ADDENDUM 3

SUBJECT: Bulverde Rd (Green Spring Dr – Redland Rd) Street Reconstruction (2022 Bond), (ID # 23-03867), Scheduled to Close: July 21, 2026; Date of Issue: June 10, 2026

THIS NOTICE SHALL SERVE AS ADDENDUM NO. 3 – TO THE ABOVE REFERENCED INVITATION FOR BIDS

BULVERDE ROAD
(GREEN SPRING TO REDLAND ROAD)
BULVERDE RD
ADD ALT #1 PLAN AND PROFILE
STA 90+00 TO STA 94+00
SHEET 1 OF 3

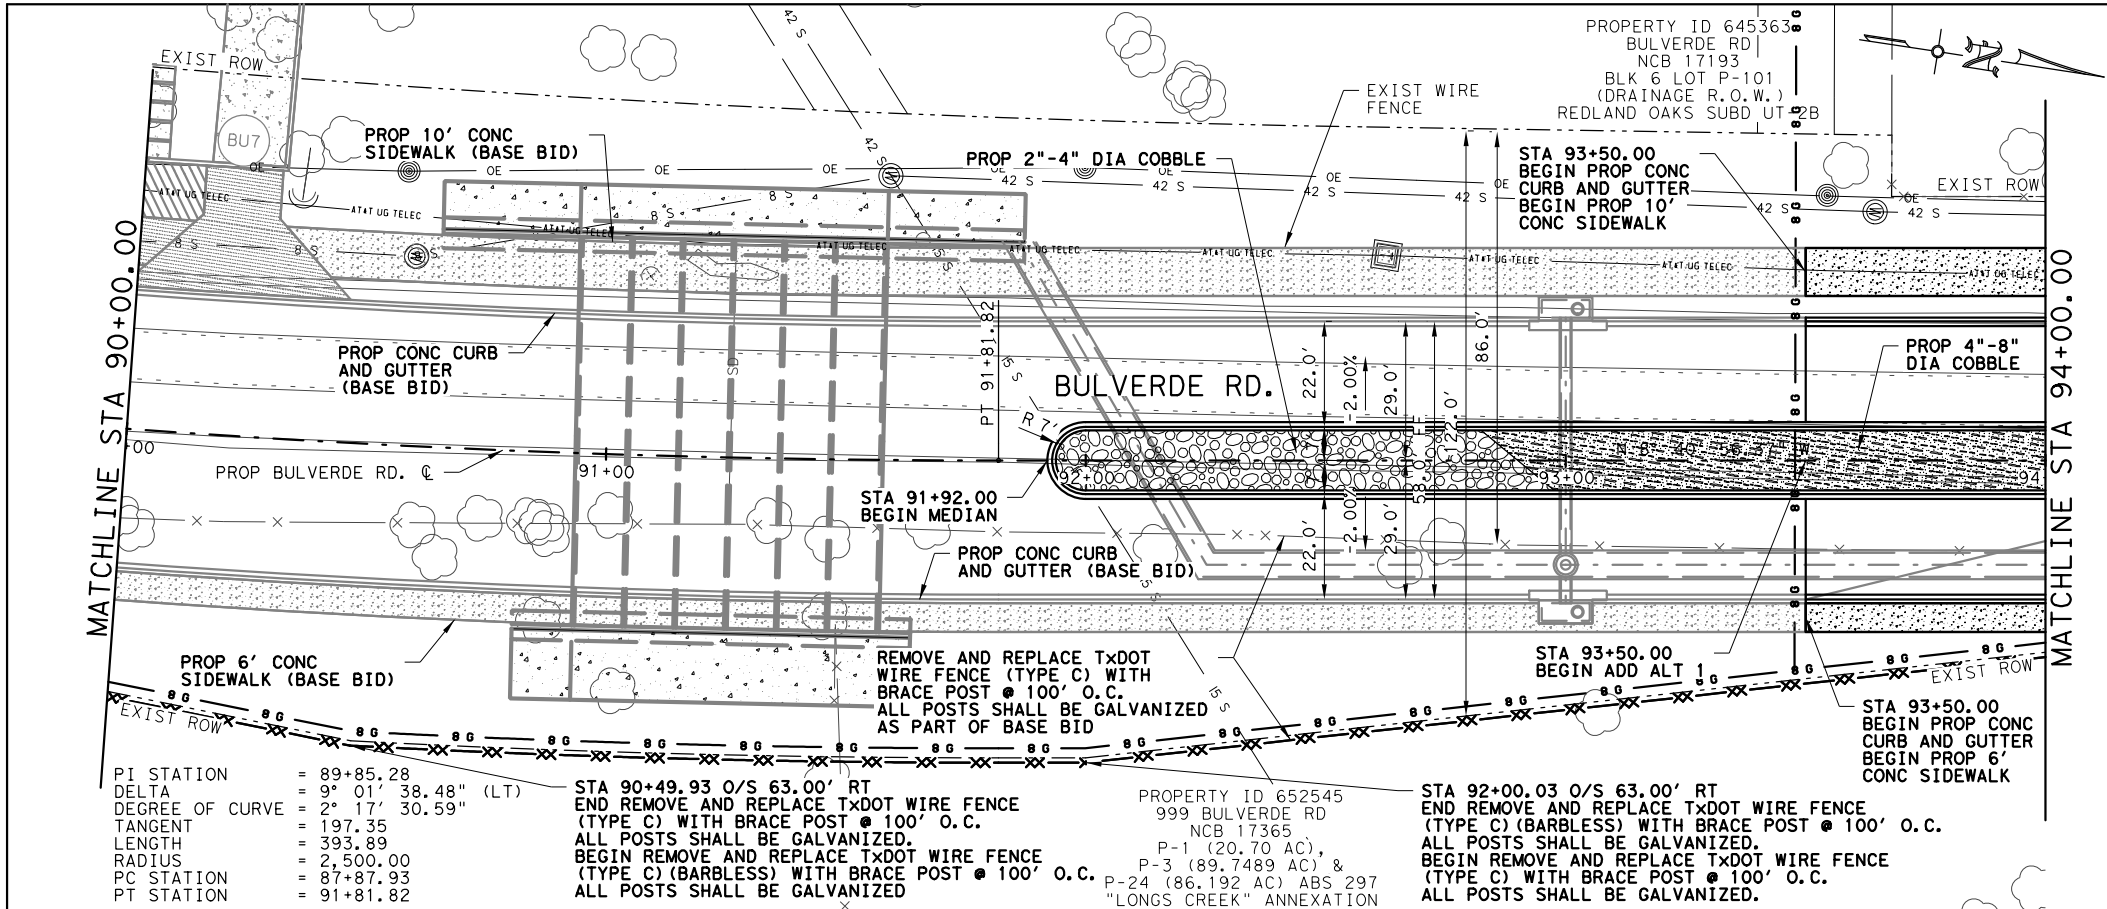
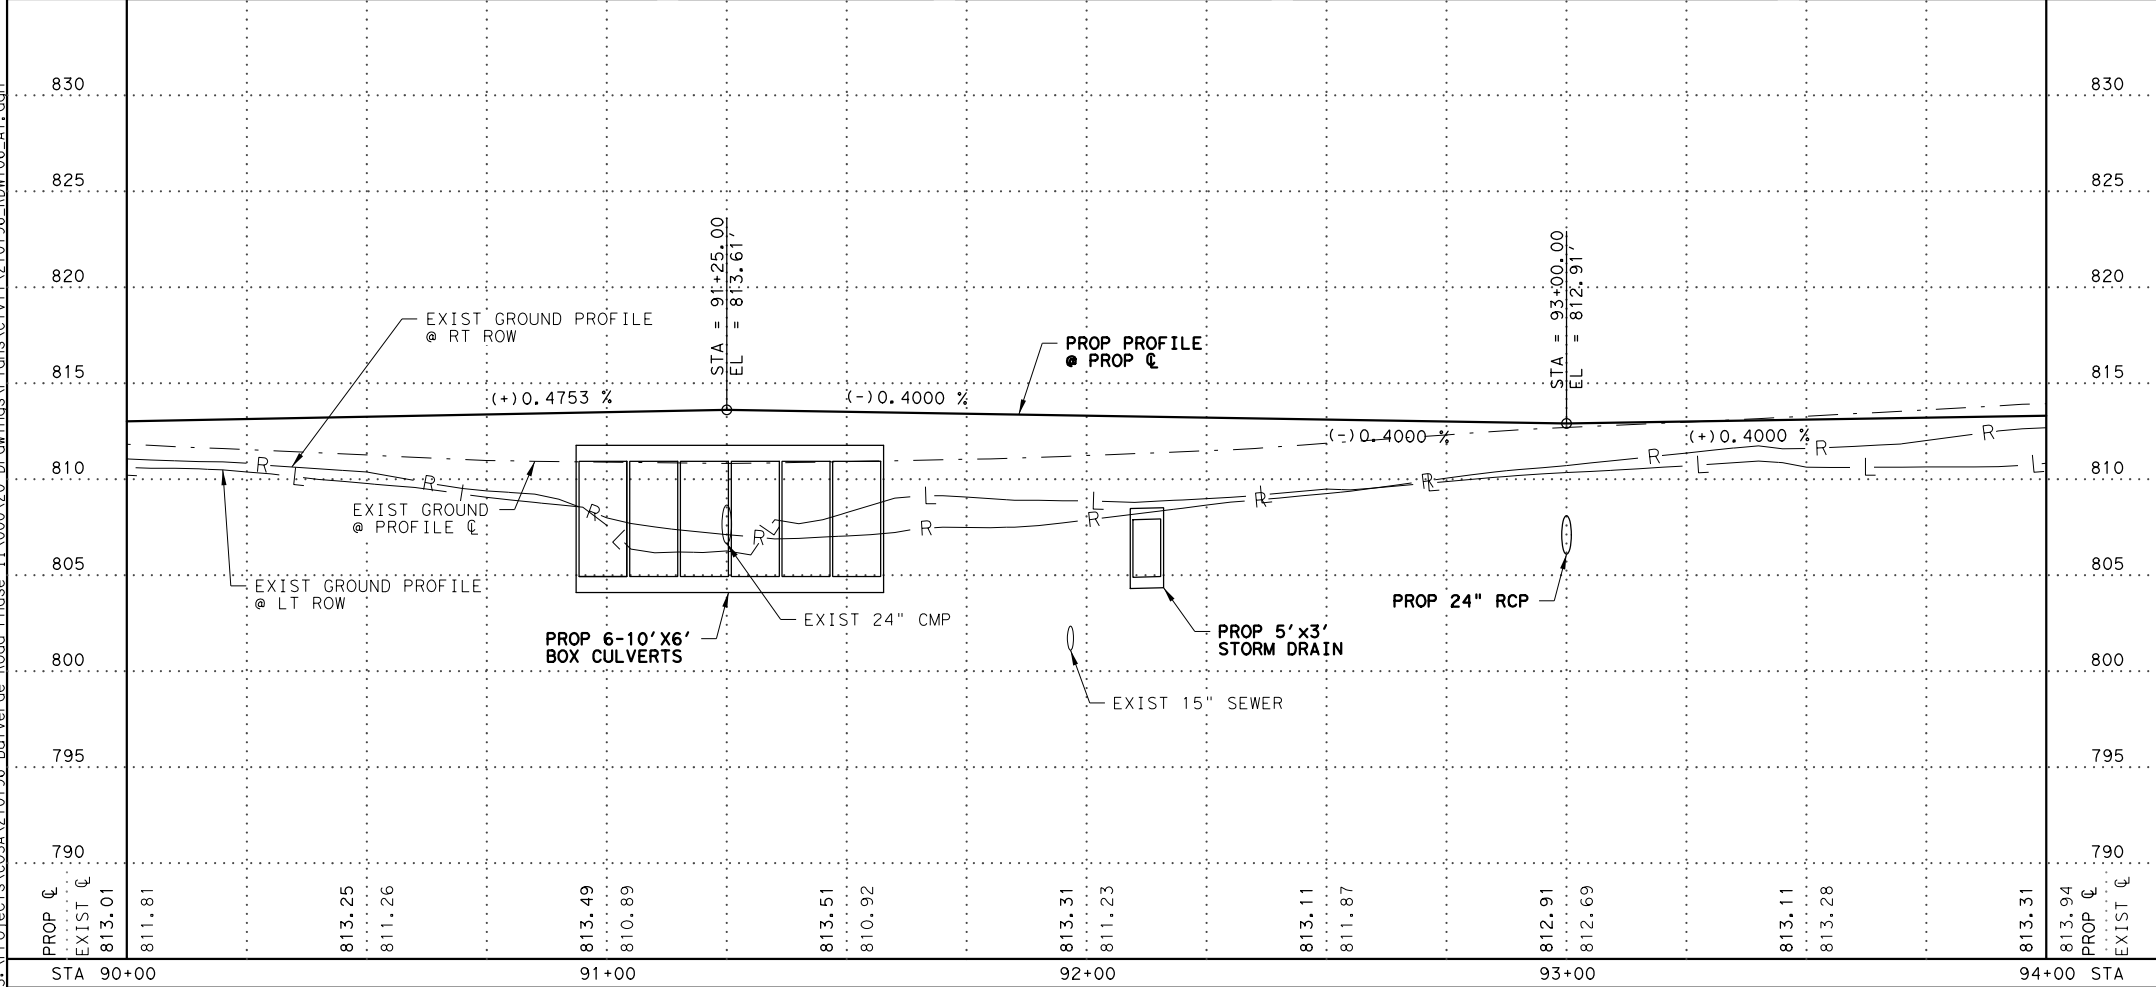
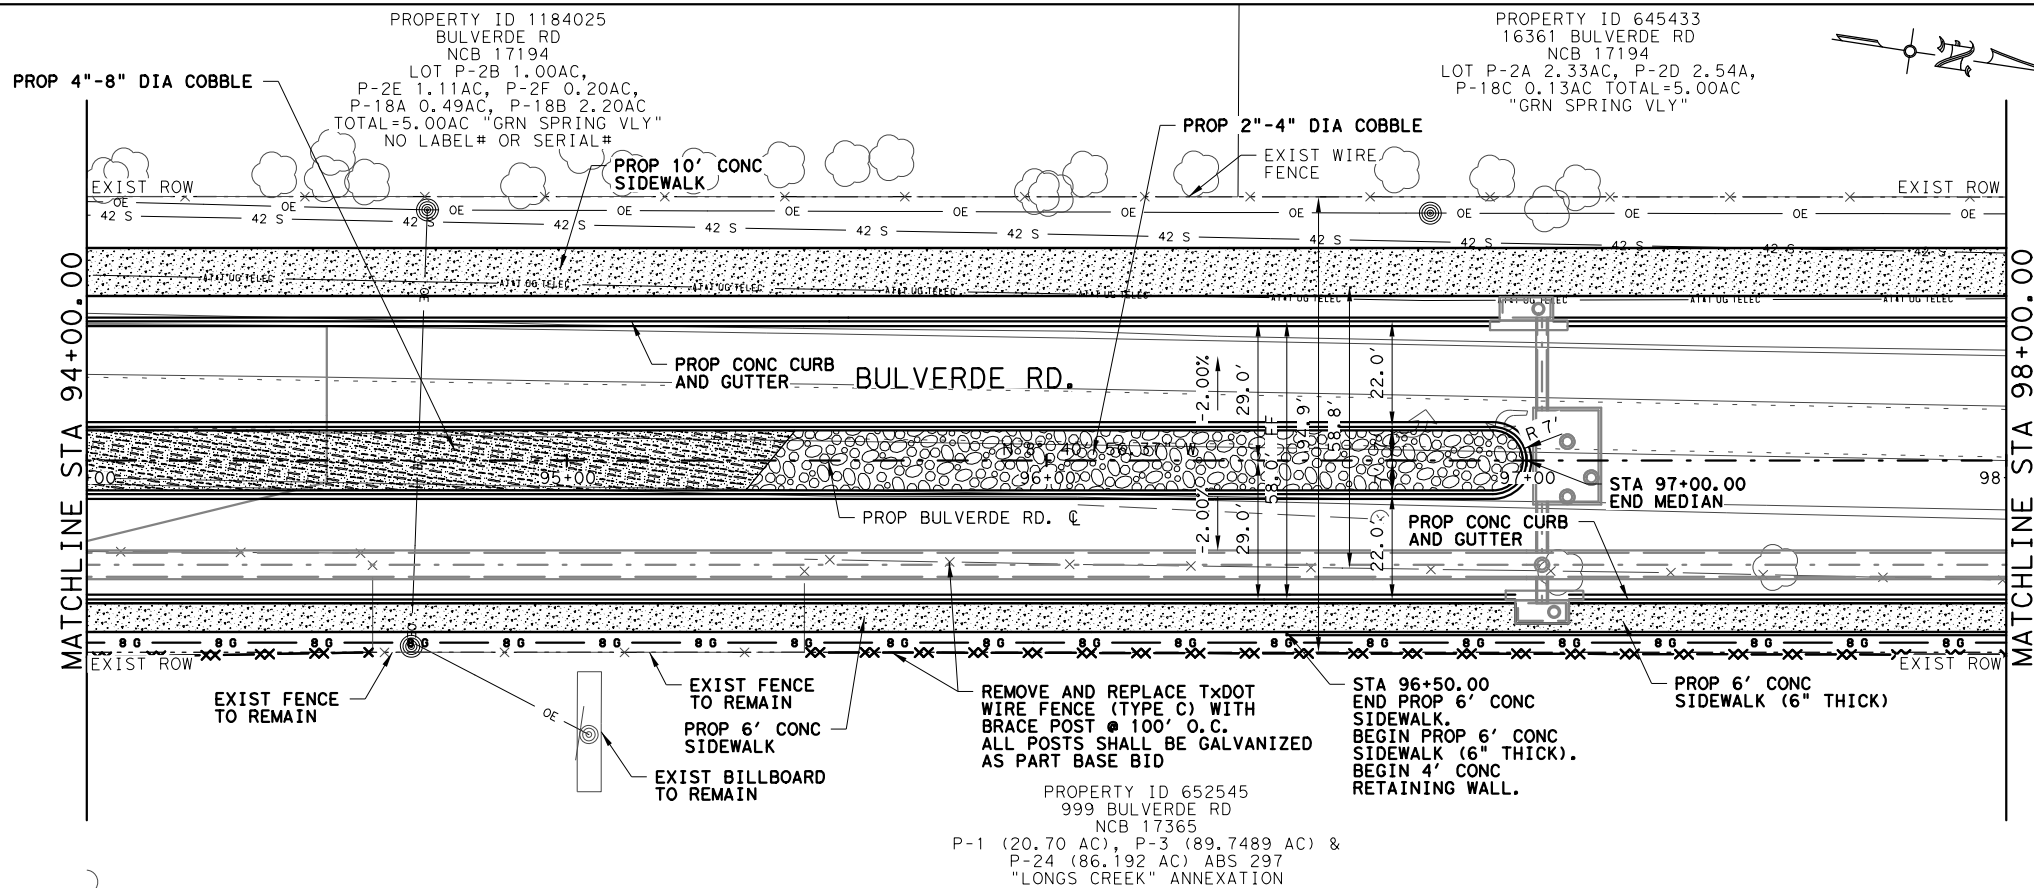
- e. REMOVE Sheet 127 and REPLACE with attached Sheet 127 to update the quantity for Item 500.4 in the quantity box on the sheet.
- f. REMOVE Sheet 128 and REPLACE with attached Sheet 128 to update the quantity for Item 500.4 in the quantity box on the sheet.

**BULVERDE ROAD
(GREEN SPRING TO REDLAND ROAD)
BULVERDE RD
ADD ALT #2 PLAN AND PROFILE
STA 98+00 TO STA 102+00
SHEET 1 OF 3**

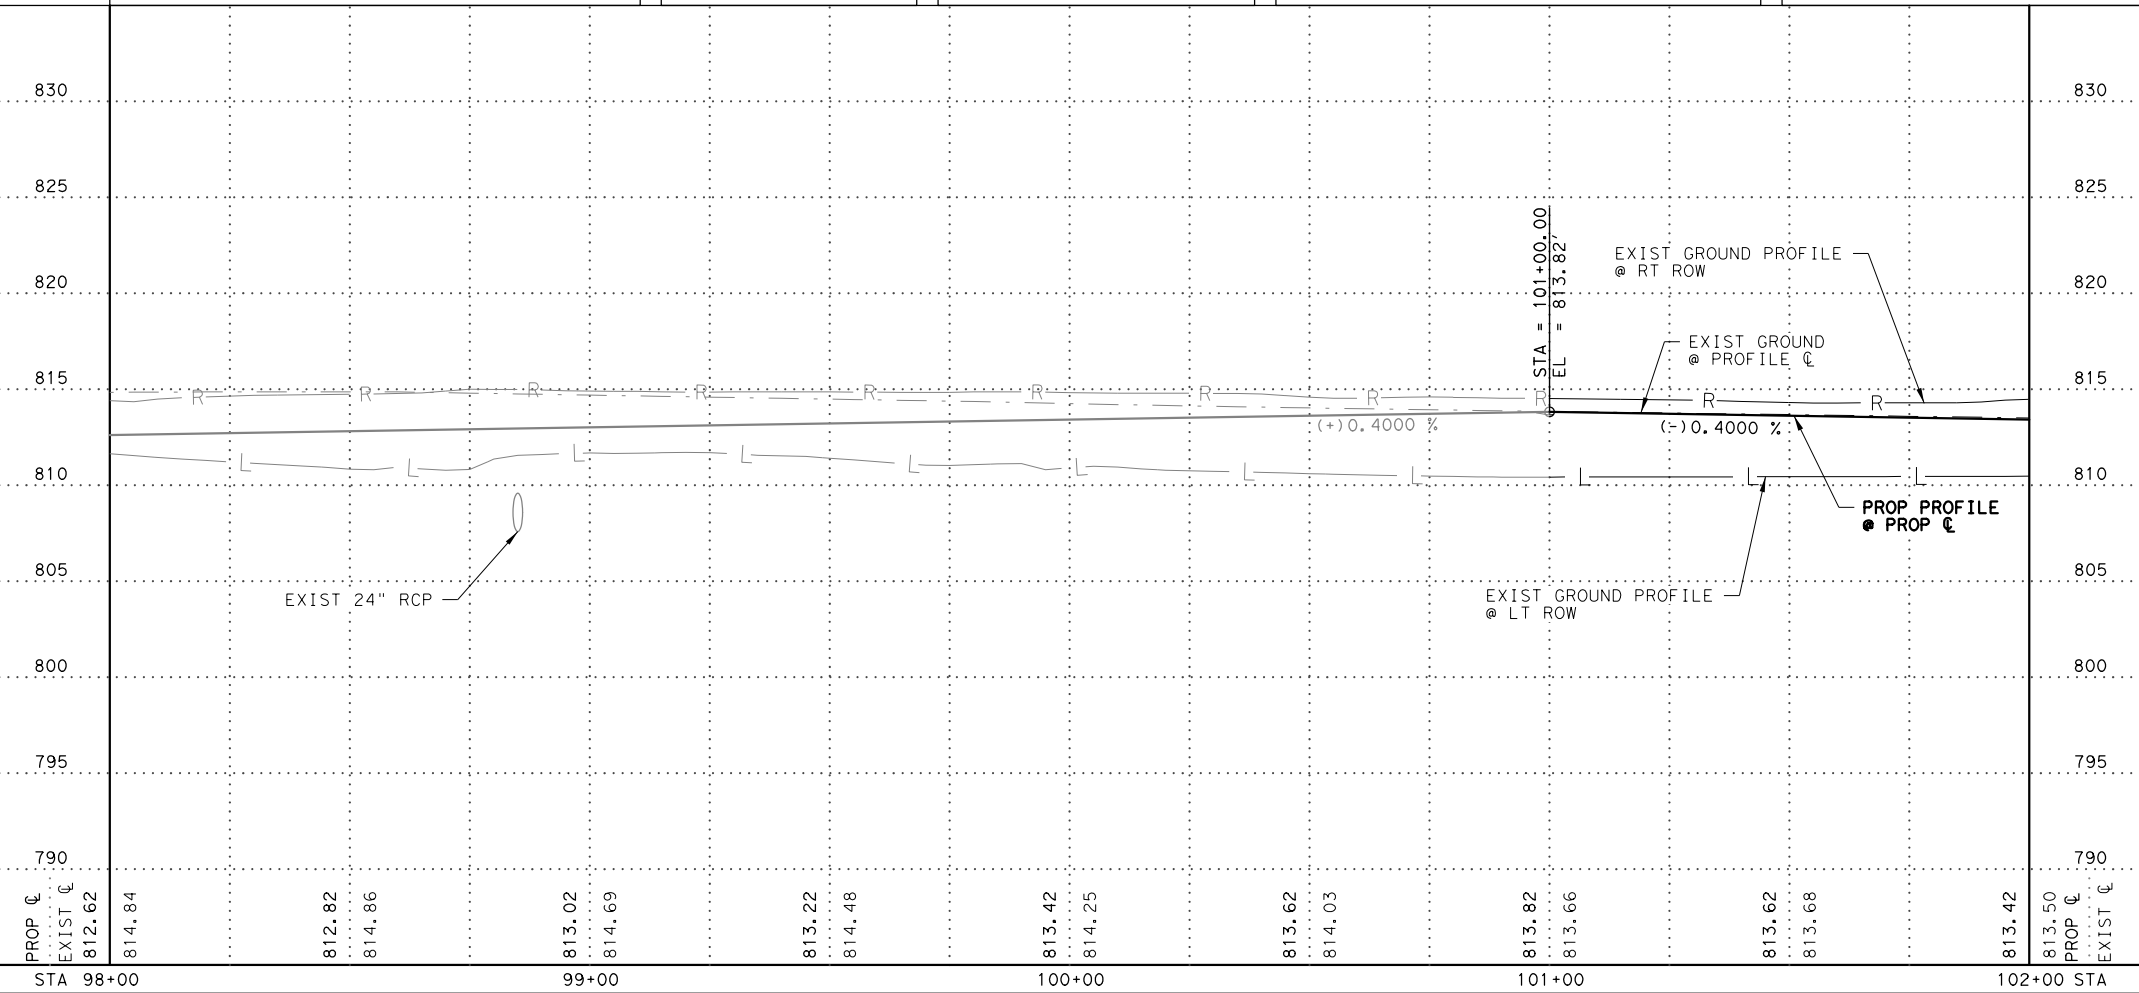
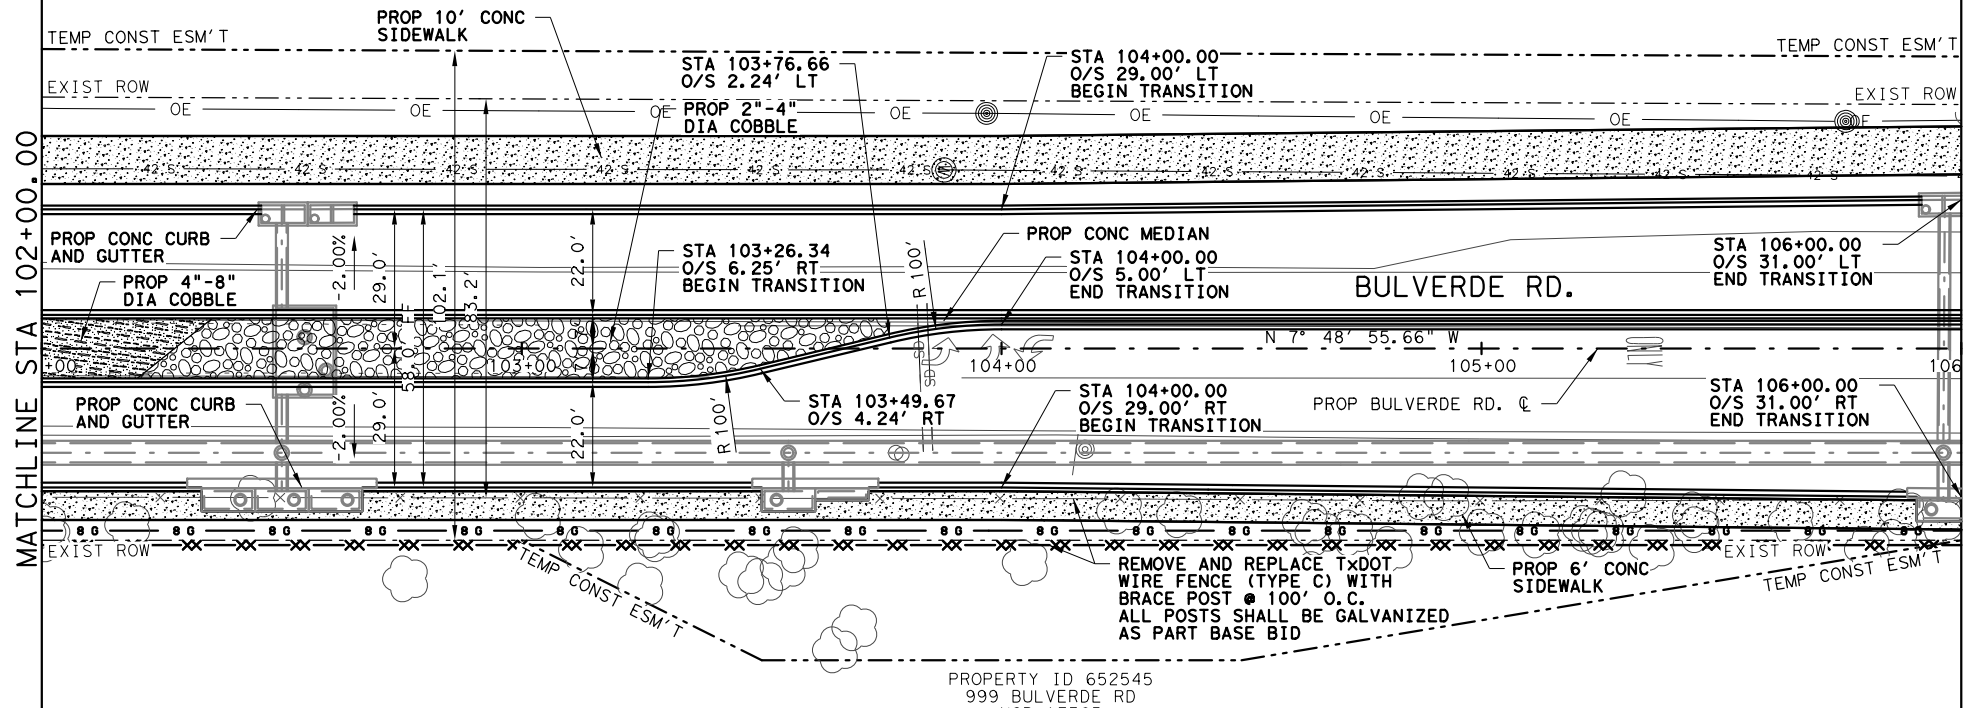
- g. REMOVE Sheet 130 and REPLACE with attached Sheet 130 to update the quantity for Item 500.4 in the quantity box on the sheet.
- h. REMOVE Sheet 131 and REPLACE with attached Sheet 131 to update the quantity for Item 500.4 in the quantity box on the sheet.
